Priority Level: Medium — Recommended Action for Affected Systems		
Attention:	All Service Personnel	Bulletin: SB-046 Date: 2/19/2009
Products:	Paradise Lost with the GA-G31MX-S2 Motherboard	
Issue:	Change BIOS setting if <i>Found New Hardware Wizard</i> appears at boot.

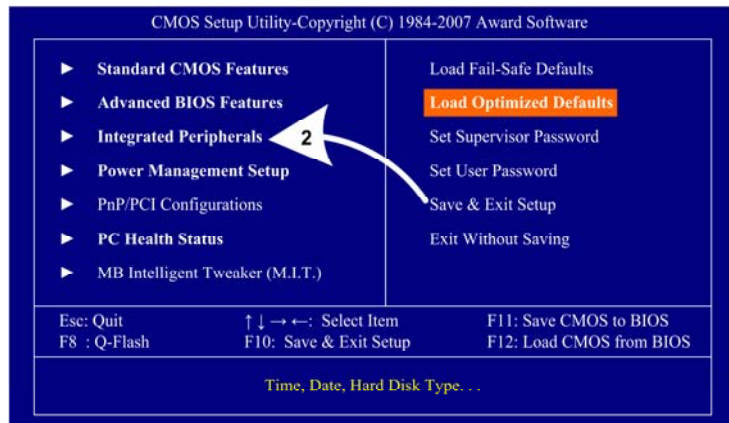
1. Power off the game and connect a keyboard to the computer. Power on and press the **DEL** key during boot. The **CMOS Setup Utility** will start.
2. Use the (↑↓) Arrow keys to highlight **Integrated Peripherals** and press **Enter**.

3. On the Integrated Peripherals menu, use the (↑↓) Arrow keys to highlight **Onboard H/W LAN**, and then use the **Page Up** and **Page Down** keys to change the setting to **Disabled**.

Save to CMOS and EXIT (Y/N) Y

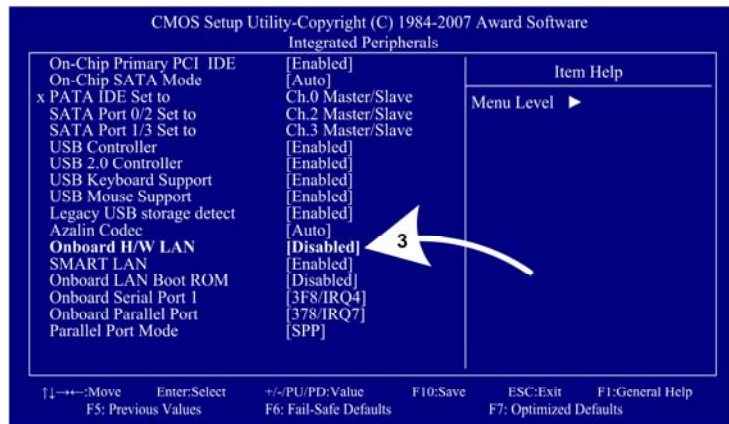
4. Press **F10**. The following prompt will appear:

5. Make sure "Y" shows at the end of the prompt (use the arrow keys to select, if necessary), and press **Enter** to save the settings and exit.
